**COVER NOTE ISSUED BY
THE INFO-COMMUNICATIONS MEDIA DEVELOPMENT AUTHORITY**

**CODE OF PRACTICE FOR
INFO-COMMUNICATION FACILITIES IN BUILDINGS 2018**

28 NOVEMBER 2018

Figure A: Recommended – Re-configuration of In-home Co-axial Cabling under COPIF 2018

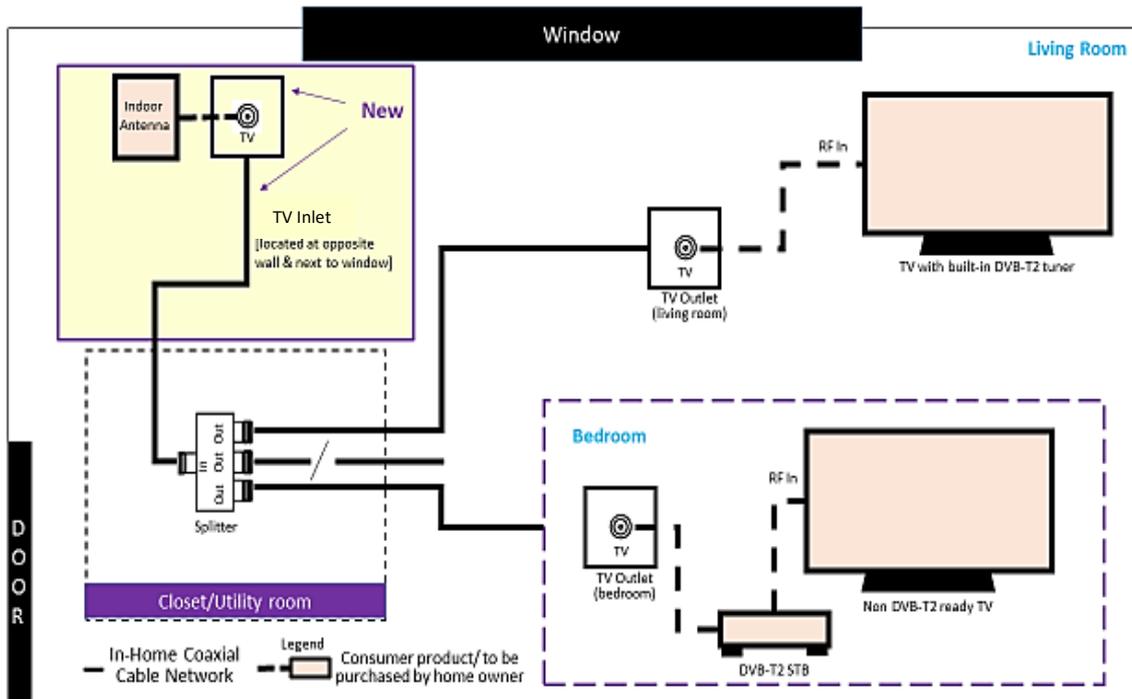
68. Given the above, including having explored the possible uses and modification of the BCS to allow home owners to continue the use of co-axial cabling for the distribution of DTV signals for FTA TV, IMDA had proposed in the Second Public Consultation the re-configuration of the co-axial cabling such that it can be used to distribute DTV signals within the home. This would allow home owners to attach an antenna to the inlet of the splitter and distribute the DTV signals to the room(s) with the co-axial cable outlets, thus eliminating the need for each TV set to be attached with separate antenna(e). Refer to Figure A.

69. One respondent, while generally supportive, had commented that the in-home co-axial reconfiguration may not be a full solution due to inherent issues, i.e. the nature of the indoor antenna. IMDA noted some of the technical issues and hence, has advised home owners to place the indoor antenna at higher places to allow better signal reception. IMDA has also proposed that the co-axial cablings for new homes be configured in the manner as illustrated in Figure A. However, IMDA strongly discourages all indoor antennae from being placed at the window ledges or sills and advises developers/owners (or their managing agents) to guide their residents accordingly.

70. In addition, it is highly recommended that affected developers/owners adopt the configuration if the BCS has not yet been installed or is in the midst of deployment, as developers/owners who adopt it will no longer need to provide co-axial cables from the gate pillar/telecom riser to new residential units, thus resulting in savings to the cost of construction. More details can be found in the COPIF Guidelines (the “**Guidelines**”) that have been revised and now published together with the COPIF 2018.
